APPLICATION FOR APPEAL

EGRESS WINDOW NON-COMPLIANCE DETERMINATION

APPEAL PROPERTY ADDRESS: 1402 FURNESS PKWY

TYPE OF WINDOW

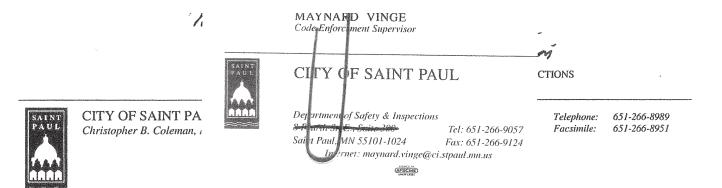
Total Glazed Area Minimum 5 Square Feet	8.3 sq.ft.	Difference from Required Area	+2.6 sq. ft.
Width of Opening Minimum 20 Inches	26"	Difference from Required Opening	+6"
Height of Opening Minimum 24 Inches	22"	Difference from Required Opening	-2"
Height of Opening to Finished Floor Maximum 48 Inches for Existing Openings	OK	Difference from Maximum Height

COMMENTS: Existing window in bedroom.
